**Queries/Responses**

**Tender No:** EI-B/GA/14/0011/2013-EBC **Dated:** 11/02/2014

**Subject:** Supply, Installation, Commissioning and Testing of Air-conditioning including all associated accessories and allied works & Fire Suppression Work at ERNET India, Bangalore

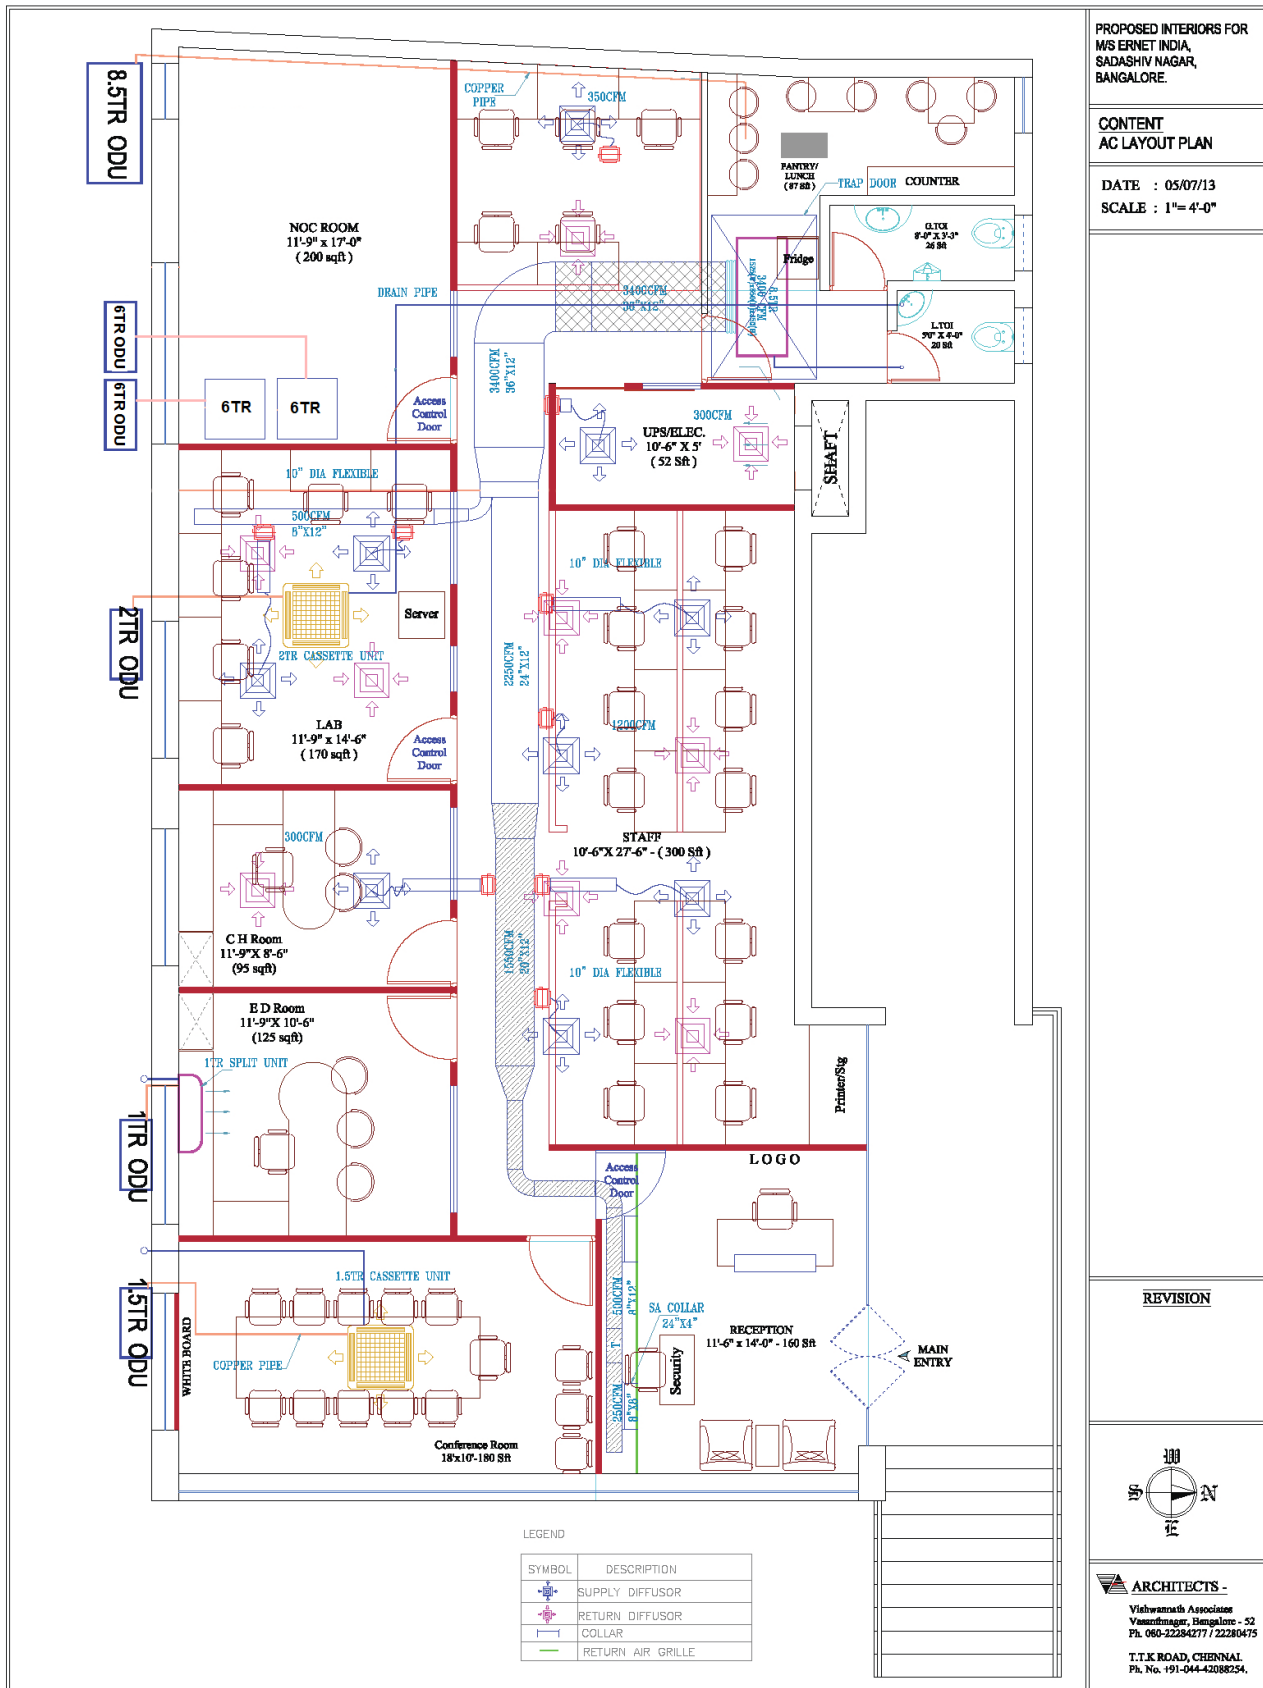
3	BOQ	General Air-conditioning	<b><u>Clarification:</u></b> As per the layout drawing Precision AC is being mentioned as 3TR, but your requirement according to the Tender is 6TR	Yes	ERNET requirement is 6TR-2no's, please see the revised layout drawing in the Annexure - II
4	BOQ	General Air-conditioning	<b><u>Clarification:</u></b> Ducting work for centralised AC has already been completed; vendor will quote for rest of the work.	Yes	Centralised AC ducting (8TR) work has already been done; vendor will quote for indoor/Outdoor unit with suitable copper piping.
